MIL-G-45654

AMENDMENT 2
15 MARCH 1963

MILITARY SPECIFICATION

GAGES, PLUG AND RING, THREAD

FIGURE 1. *Removal of partial thread and chip groove.*

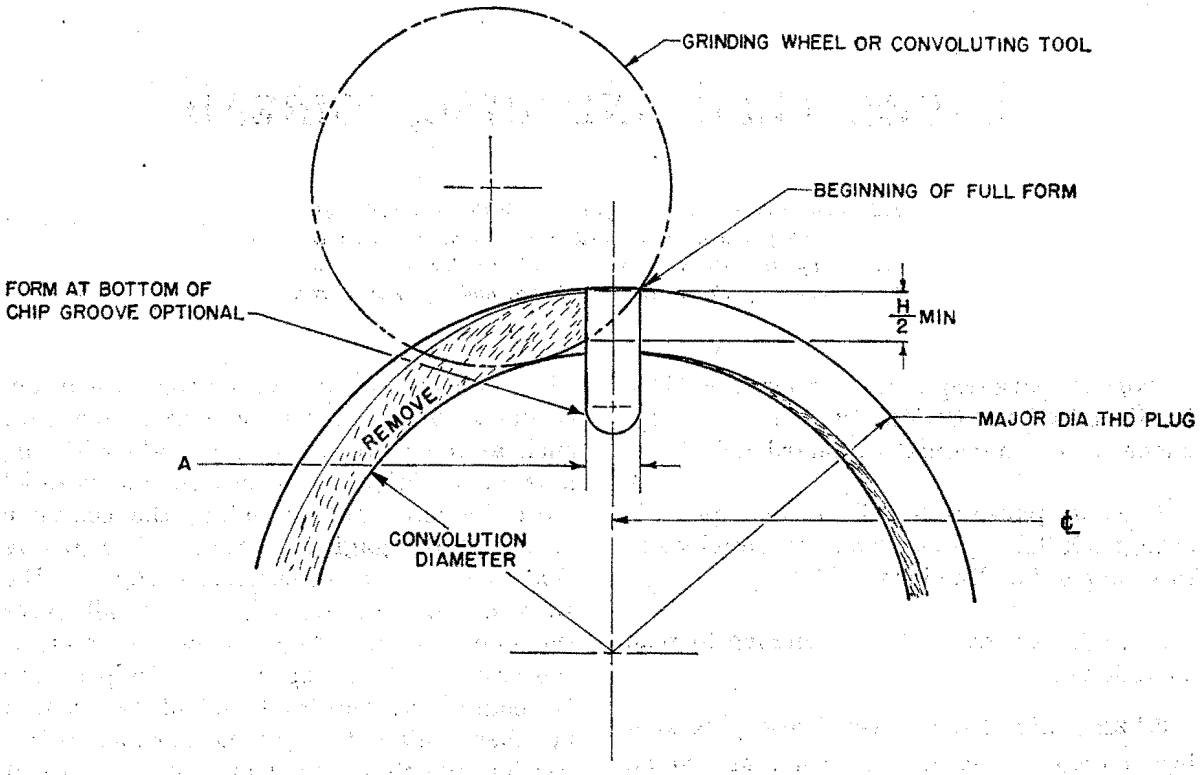
Page 3, paragraph 3.1.2.3, On page 4, 7th line, add after ". . . root of the thread." "The convolution rise due to the radius of the convoluting tool shall be no greater than H/2 measured from the major diameter of the Go thread plug gage as shown in figure 1. The beginning of the first full thread shall be sharp and of full form and contain no indentations or nicks.
